FINAL DEVELOPMENT PLAN

FED ONE
CLAYCRAFT WAREHOUSE
CITY OF GAHANNA
FRANKLIN COUNTY, OHIO

Subject: Claycraft Warehouse- Design Review Comments
City of Gahanna, Franklin County, Ohio
CEC Project 182-564

RE: Project 870 Claycraft Rd Design Review Comments

Job Name: CLAYCRAFT
Lighting Layout Version A

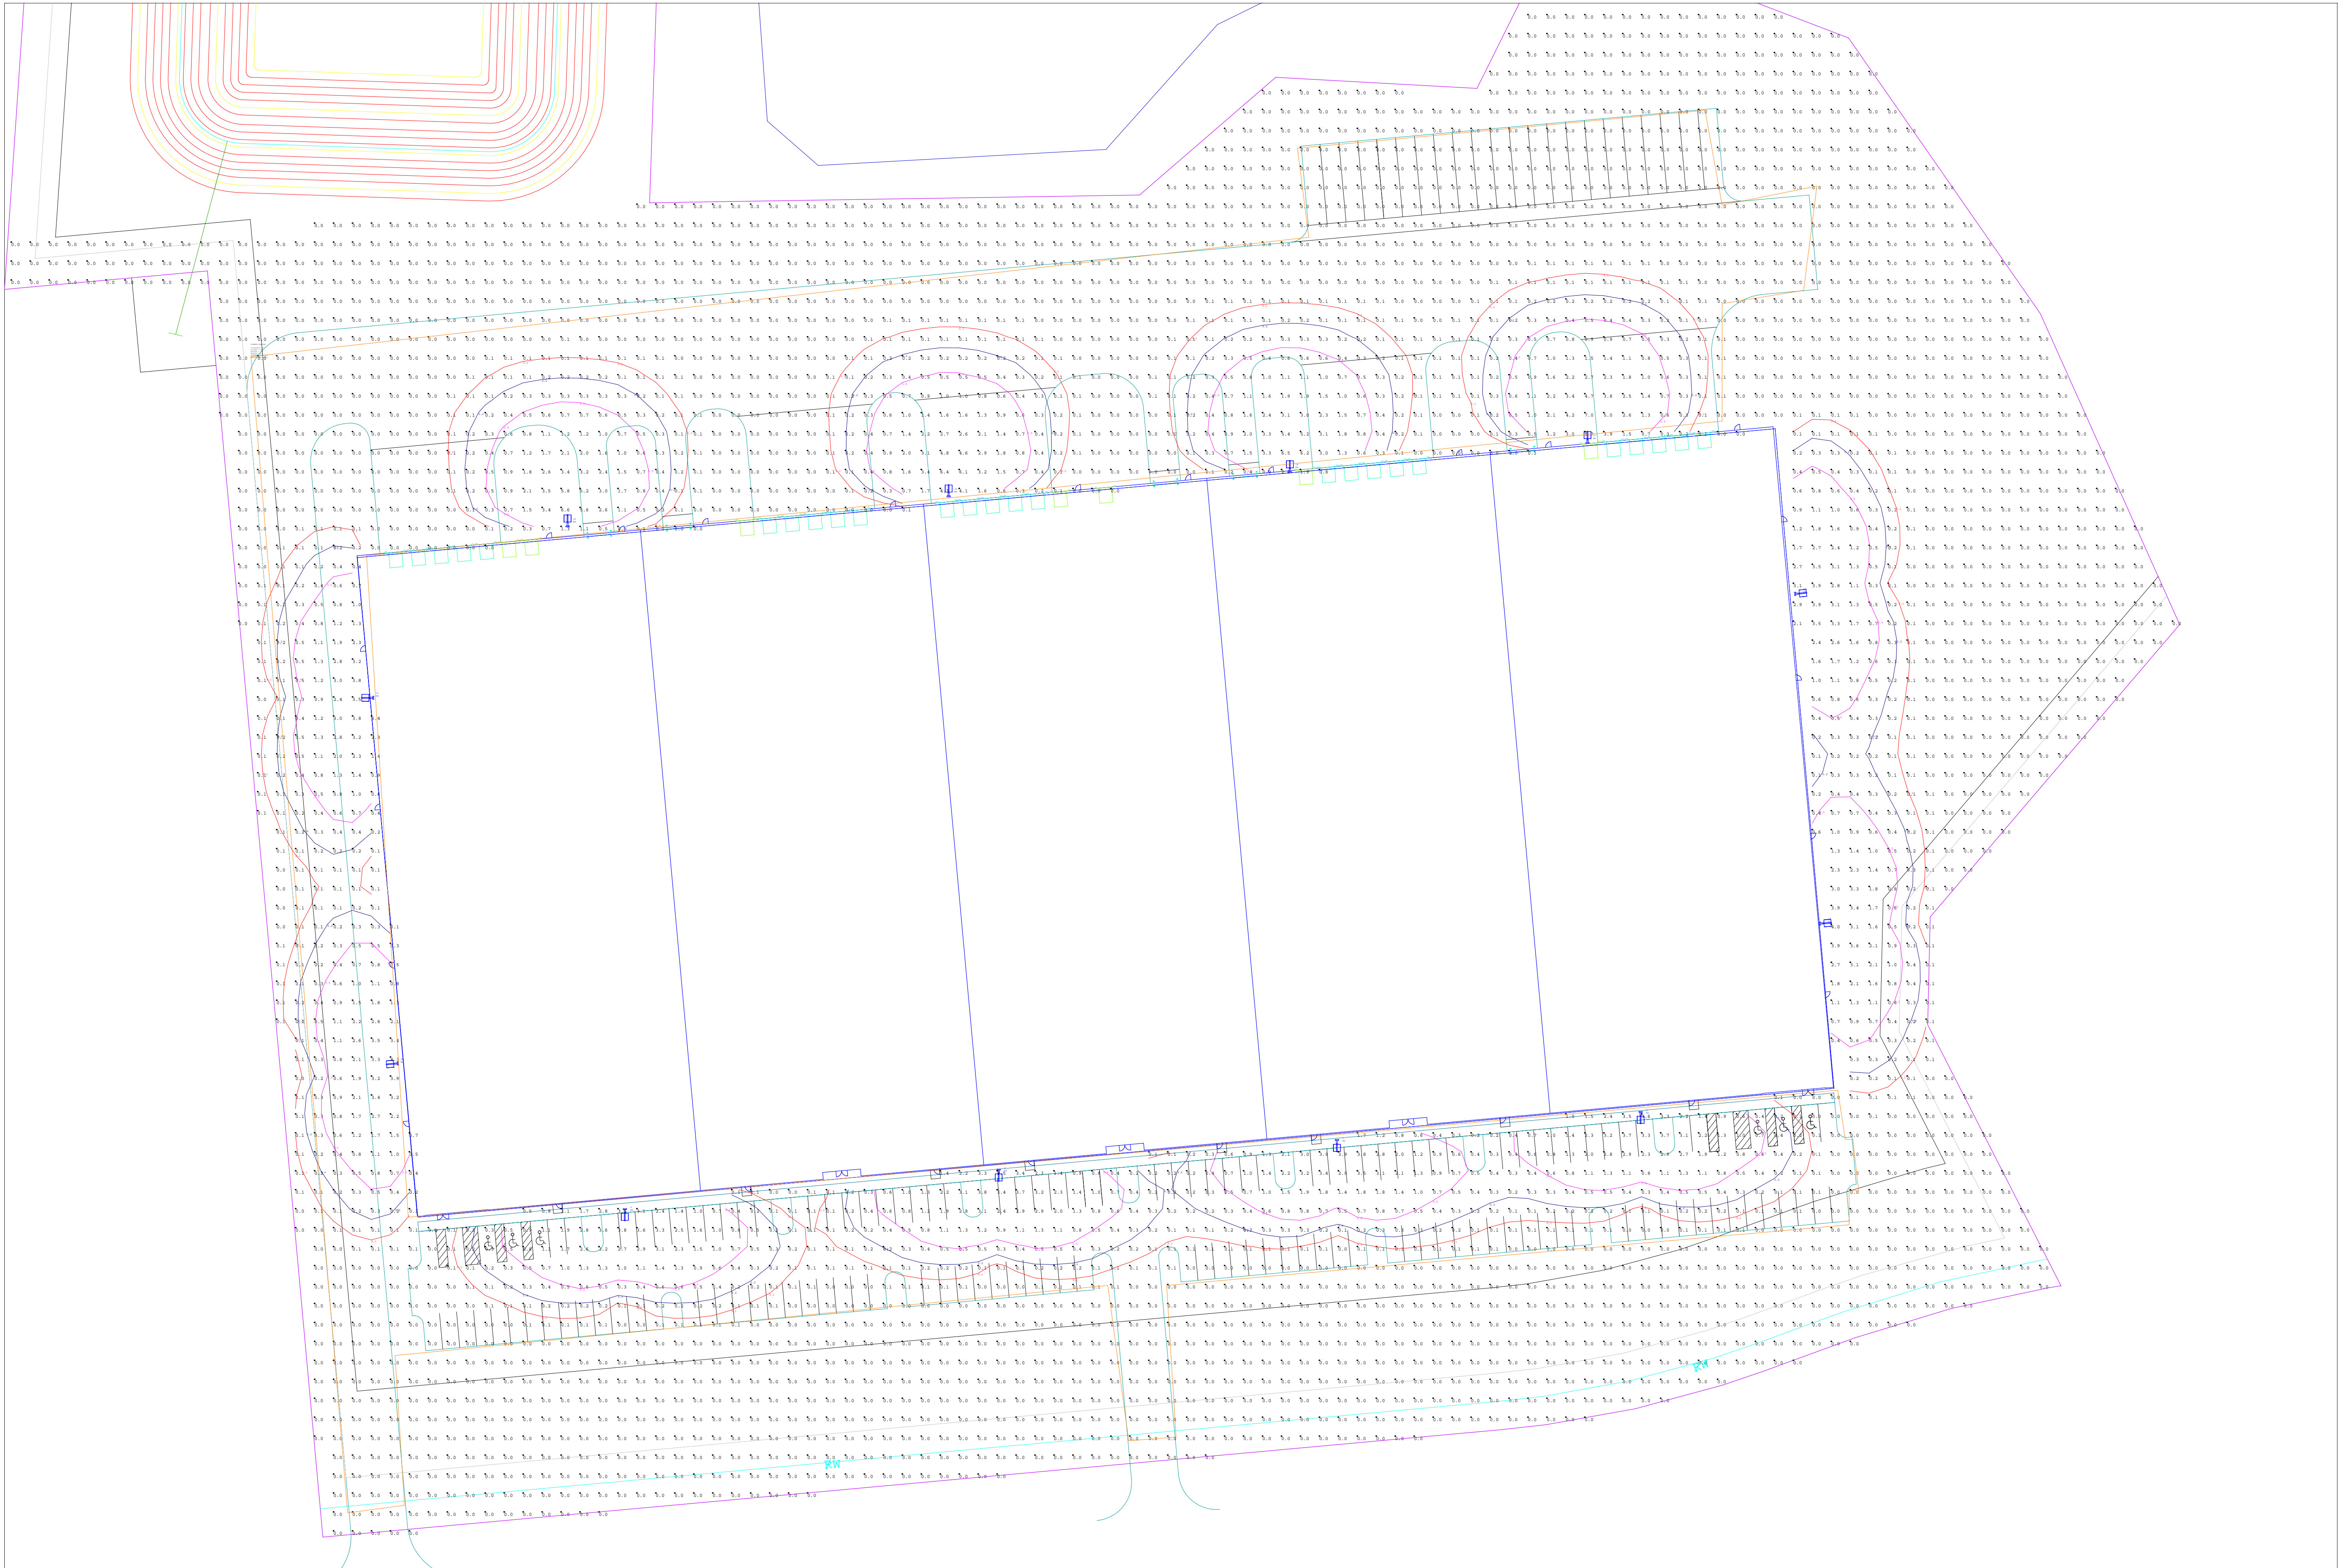
5. CH 1163.06 requires the average intensity of parking lot lighting to be 1/2 foot candles. Please revise the photometric plan to include average intensity.

12/10/18 - It appears that the calculation summary is indicating an average intensity of 2.8 at the pavement. The code limits this to .5. Please revise accordingly or request a variance.

Lighting plan has been revised to 1/2 foot candles +/-.
